NOTIFICATION OF TRANSMITTAL OF  
INTERNATIONAL PRELIMINARY  
EXAMINATION REPORT

## INTERNATIONAL PRELIMINARY EXAMINATION REPORT

Light sensitive  
Display

WRITTEN OPINION  
(PCT Rule 66)

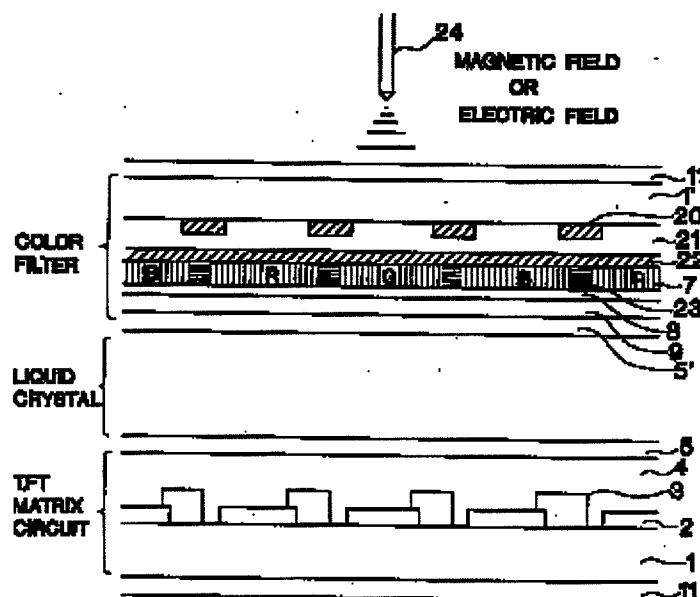
Claims 10, 11, 16, 18 and 23 lack novelty under PCT Article 33(2) as being anticipated by Kim, USPAT 5,568,292.

Kim discloses and shows in Fig. 5, an active matrix light sensitive display comprising:

(a) a light valve including a front polarizing element (11), a rear polarizing element (11), and a liquid crystal material (applicant's light rotating material) located between the front polarizing element and the rear polarizing element; and

(b) a plurality of thin film transistors (3) (applicant's light sensitive elements) located between either the front polarizing element or the rear polarizing element and the light rotating material. Accordingly, claims 10, 11 and 23 are anticipated.

As to claim 16, Kim also shows in Fig. 5 that the display also comprising:

a transparent counter electrode layer (9) (applicant's front electrode layer), a transparent picture element electrode (2) (applicant's rear electrode layer), and a liquid crystal material (applicant's light rotating material) located between the front electrode layer and the rear electrode layer wherein the front electrode layer and the rear electrode layer defining a plurality of pixels within the light rotating material.

As to claim 18, Kim also shows in Fig. 5 that the plurality of light sensitive elements (3) are located at least partially between the pixels, with respect to a perpendicular direction to the front of the display.

**Fig. 3**

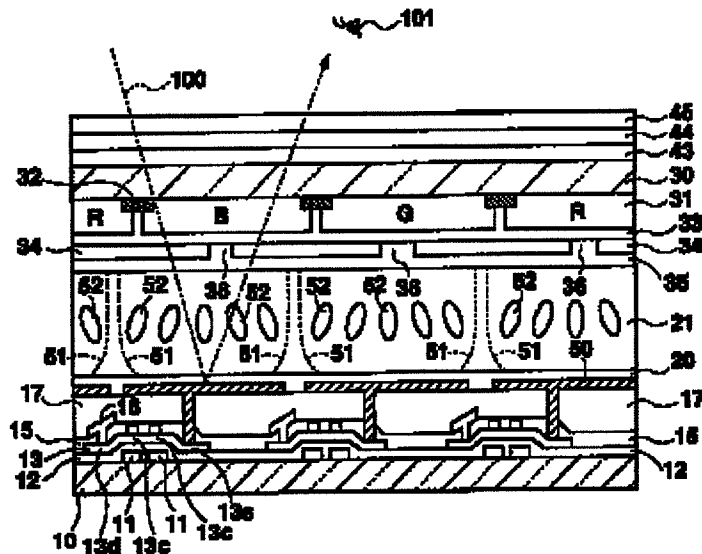
Claims 27-29 lack novelty under PCT Article 33(2) as being anticipated by Noritake et al., (Noritake), US 2001/0046013.

Noritake discloses (page 2, paragraph 0032-0035) and shows in Fig. 3, a light sensitive active matrix liquid crystal display comprising:

reflective display electrode (50) and counter electrode (34);  
liquid crystal material (20); and

a plurality of TFT (applicant's light sensitive elements) located within the display wherein the display selectively causing the pixels to provide a bright

and uniform image (bright and uniform image is obtained by causing the pixels to provide light).  
Accordingly, claims 27-29 are anticipated.

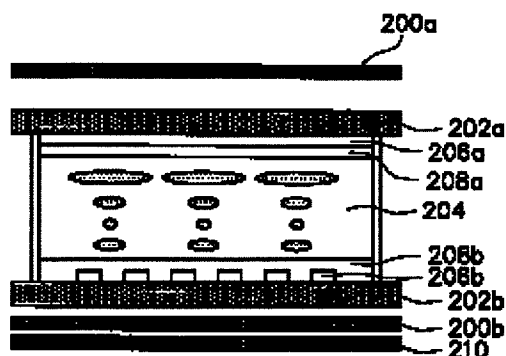
Yang discloses a liquid crystal display comprising transparent front (206a) and rear electrode (206b) layer (Fig. 2). Yang also discloses that by continuously altering the applied voltage between transparent electrodes (206a and 206b), various colors can be displayed by variation of polarization status of red, green and blue lights with different wavelengths (col. 6, lines 3-6).

Yang is evidence that ordinary workers in the art of liquid crystal would find a reason, suggestion or motivation to change the electrical potential between two transparent electrodes.

Therefore, it would have been obvious to one of ordinary skill in the art at the time of the invention was made to modify the display of Kim by changing the electrical potential between the rear electrode layer and the front electrode layer to selectively modify portions of the liquid crystal material to change the polarization of the incident light so that various color can be displayed.

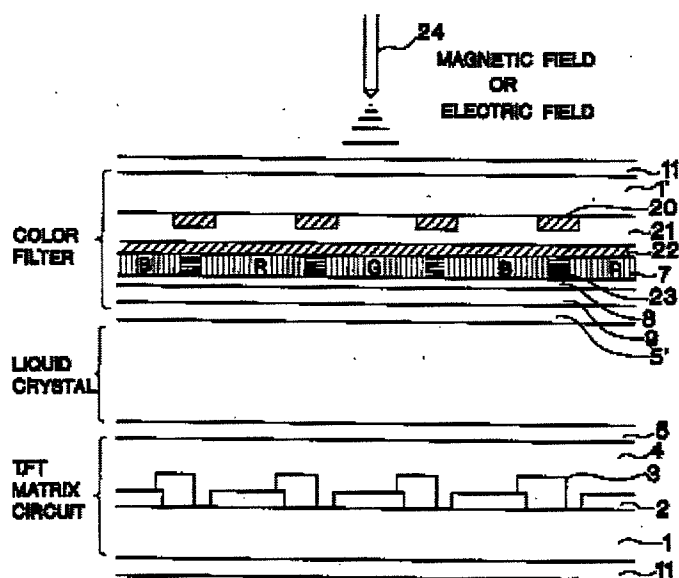
Claims 10, 11, 16, 18 and 23 lack novelty under PCT Article 33(2) as being anticipated by Kim, USPAT 5,568,292.

Kim discloses and shows in Fig. 5, an active matrix light sensitive display comprising:

(a) a light valve including a front polarizing element (11), a rear polarizing element (11), and a liquid crystal material (applicant's light rotating material) located between the front polarizing element and the rear polarizing element; and

(b) a plurality of thin film transistors (3) (applicant's light sensitive elements)

As to claim 16, Kim also shows in Fig. 5 that the display also comprising:  
a transparent counter electrode layer (9) (applicant's front electrode layer), a  
transparent picture element electrode (2) (applicant's rear electrode layer), and a liquid crystal material (applicant's light rotating  
material) located between the front electrode layer and the rear electrode layer wherein the front electrode layer and the rear electrode  
layer defining a plurality of pixels within the light rotating material.

As to claim 18, Kim also shows in Fig. 5 that the plurality of light sensitive elements (3) are located at least partially between the pixels, with respect to a perpendicular direction to the front of the display.

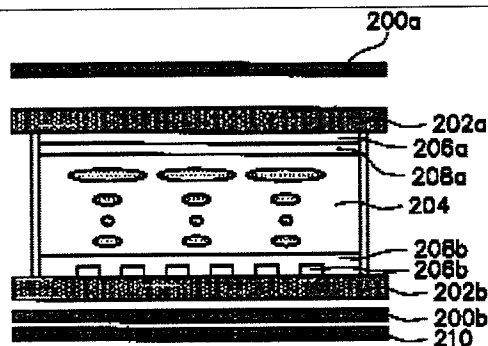
Yang discloses a liquid crystal display comprising transparent front (206a) and rear electrode (206b) layer (Fig. 2). Yang also discloses that by continuously altering the applied voltage between transparent electrodes (206a and 206b), various colors can be displayed by variation of polarization status of red, green and blue lights with different wavelengths (col. 6, lines 3-6).

Yang is evidence that ordinary workers in the art of liquid crystal would find a reason, suggestion or motivation to change the electrical potential between two transparent electrodes.

Therefore, it would have been obvious to one of ordinary skill in the art at the time of the invention was made to modify the display of Kim by changing the electrical potential between the rear electrode layer and the front electrode layer to selectively modify portions of the liquid crystal material to change the polarization of the incident light so that various color can be displayed.
